AGENDA
Planning and Zoning Commission
January 2, 2020 – REGULAR MEETING

TOWN OF JACKSON PLANNING COMMISSION AGENDA DOCUMENTATION

Section 8.3.2 Development Plan

Drawing Name
SITE PLAN

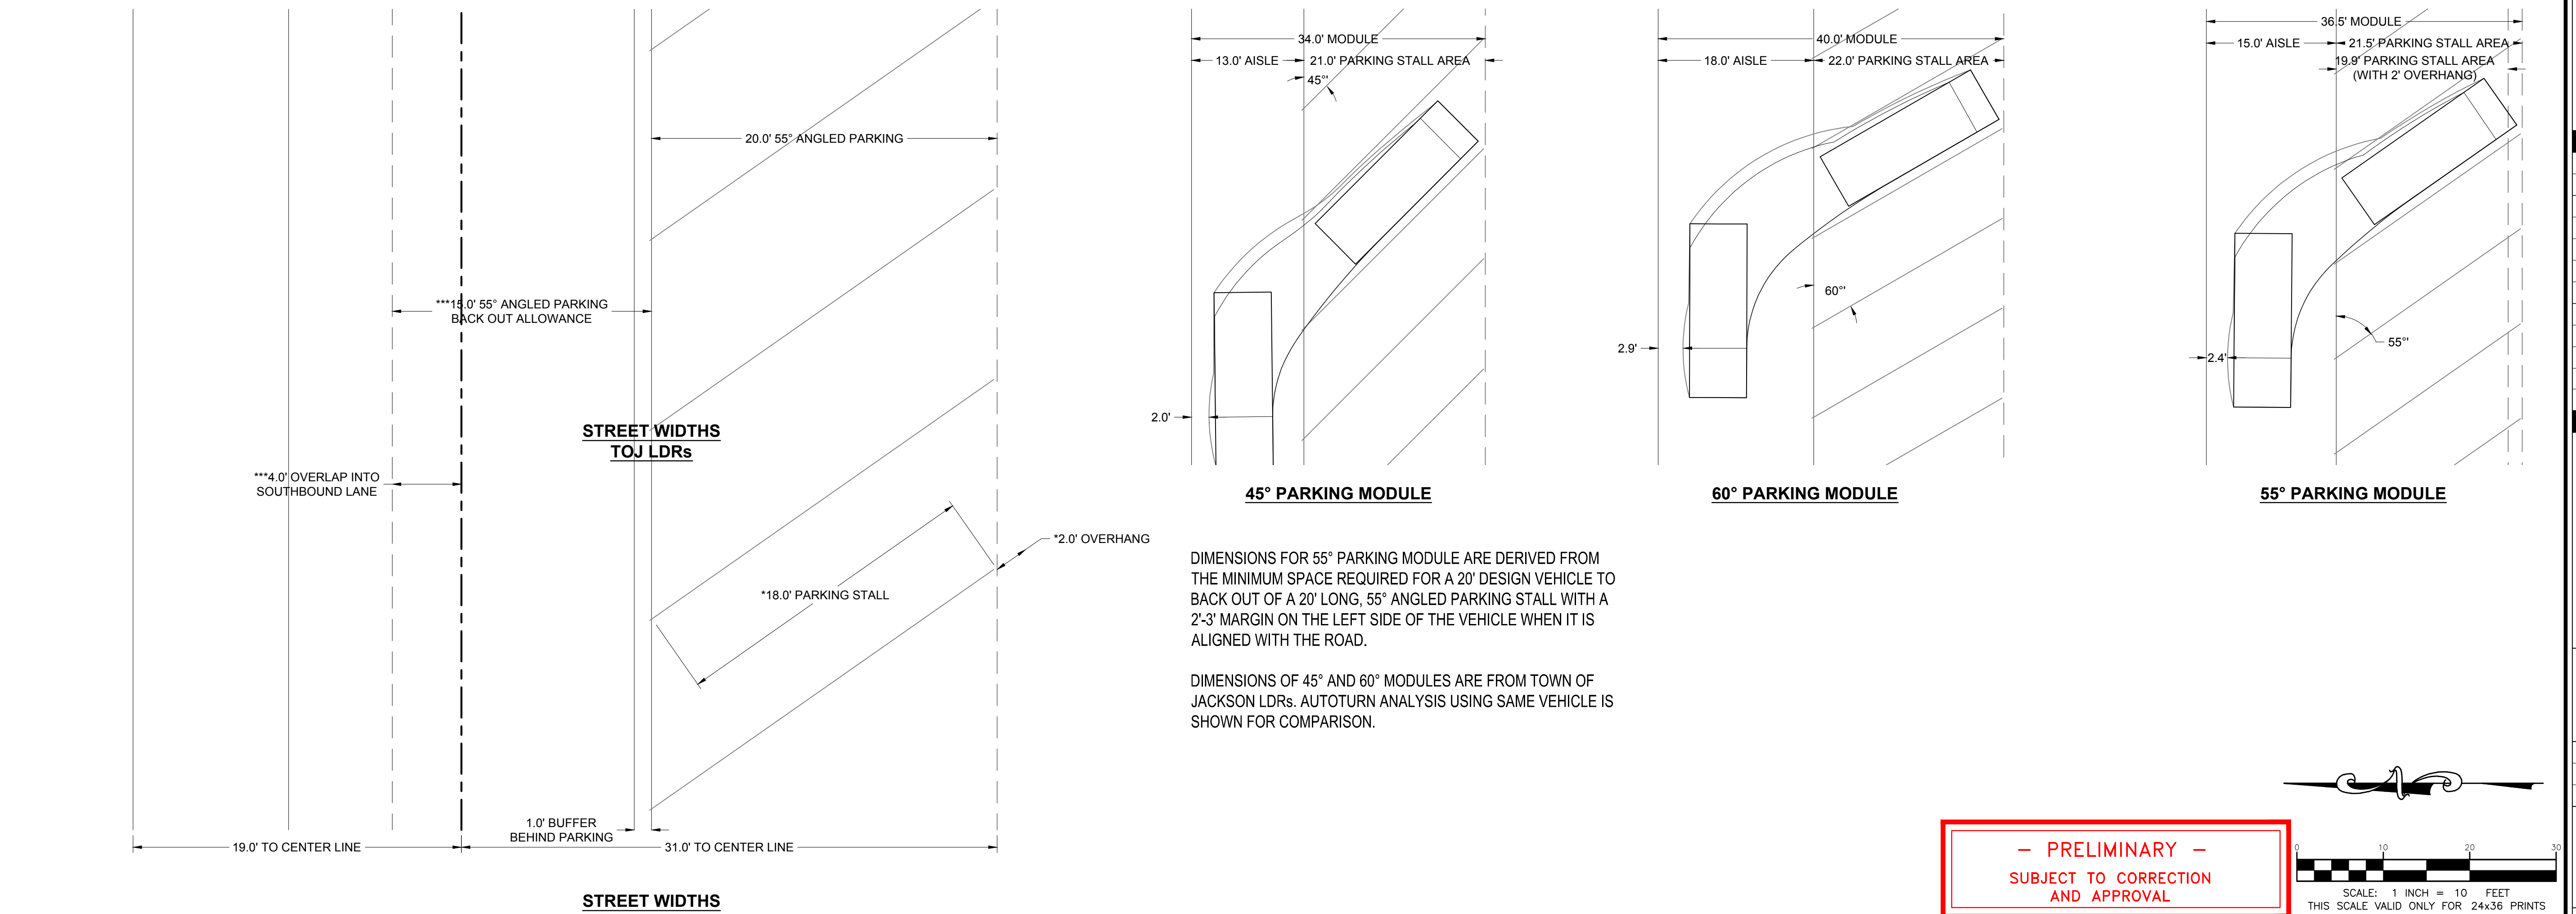
9	Engineering	<i>Sheet C2.0 and C2.1: It is not clear if there is a proposed shift in the existing centerline of Glenwood. Existing and proposed centerlines from north to south through the intersection should be shown and any changes dimensioned.</i>	See existing and proposed street dimensions on C2.1
10	Engineering	<i>Sheet C2.1: Currently redevelopment of the curb and sidewalks at this intersection are not contemplated in the Town's CIP.</i>	All curb changes not directly associated with this project removed. Project plans to construct proposed relocated curb on west side of Glenwood adjacent to project
11	Engineering	<i>Sheet C2.1: Measurements from aerial images indicate that the angle parking along the east side of North Glenwood are 60-degree parking spaces and not the 45-degree spaces shown. Clarify if the design is intended to change the angle of parking on the east side of the road, and if so, indicate how many parking spaces will be lost.</i>	Spaces to be adjusted to 55-degree angle, no spots will be lost. See turning analysis on C2.1

21	Engineering	<i>A preliminary stormwater management plan for the site shall be provided on the plans consistent with the LDR's.</i>	Connection to TOJ stormwater system provided on C2.0. Internal routing to be provided by MEP. Discharge strategy consistent with LDR's provided in Engineer's report.
22	Engineering	<i>A complete grading and erosion control plan shall be provided on the plans consistent with the LDR's.</i>	A complete grading and erosion control plan consistent with LDRs will be provided as part of the building permit package
23	Engineering	<i>Site contours, spot elevations, grades, (existing and proposed) shall be provided on the plans beyond all property boundaries per the LDR's to ensure the development's integration into the surrounding public and private property.</i>	Contours and notes indicating connection to adjacent development provided. Spot elevation and detailed grades will be provided as part of the building permit package.

24	Engineering	<i>A parking and access plan per the LDR's shall be required. The dimensions of the parking spaces and drive lanes, including turning movements (both ingress and egress), shall be clearly shown on the plans for review.</i>	Changes to surface street geometry beyond those detail on sheet C2.1 are not part of this project. Dimensioned basement parking garage plan with turning movements will be provided as part of the building permit package.
25	Engineering	<i>A pedestrian corridor plan within the right of way shall be provided for review. This shall include all dimensions and elevations in relation to existing curb and future development together with ADA compliance. Show all running and cross slopes as well as grade breaks. The buffer/landscaping strip is not to accommodate grade changes across the property and should provide grades that are traversable and do not interfere with snow plowing.</i>	ADA compliant Glenwood Street sidewalk, Gill Avenue Sidewalk, intersection ramps and connection to existing sidewalk adjacent to project provided on C2.0. Spot elevation will be provided as part of the building permit package.

26	Engineering	<i>Show Radius dimensions on all proposed curb returns within the right-of-way.</i>	Curb radius consistent with community streets plan provided on C2.0
27	Engineering	<i>If awnings or canopies are proposed within the right-of-way, dimensional and drainage information shall be included on the plans. Encroachment Agreements are required for portions of the structure that encroach into the right-of-way.</i>	No awnings or canopies encroach into the right-of-way
28	Engineering	<i>All work to be completed within the Town's right-of-way shall be specifically addressed.</i>	No portions of structure encroach into the right-of-way
29	Engineering	<i>All onsite power and cable utilities shall be shown as underground and location(s) of transformers and other communication pedestals indicated</i>	Points of connection addressed on C2.0. No new overhead lines proposed, 1 span and several services of existing overhead utilities will be buried.

30	Engineering	<i>Snow storage areas for the site shall be indicated on the plans. A large area is proposed for snow melt. In the current economy and energy market this is a solution. However, other large scale snow melt systems have been installed within the Town and for various reasons, repair, cost of operations, etc. they are no longer used. Include discussion for alternatives to the snow melt in the event it no longer functions or is economically feasible.</i>	Areas useable for snow storage provided on C2.0
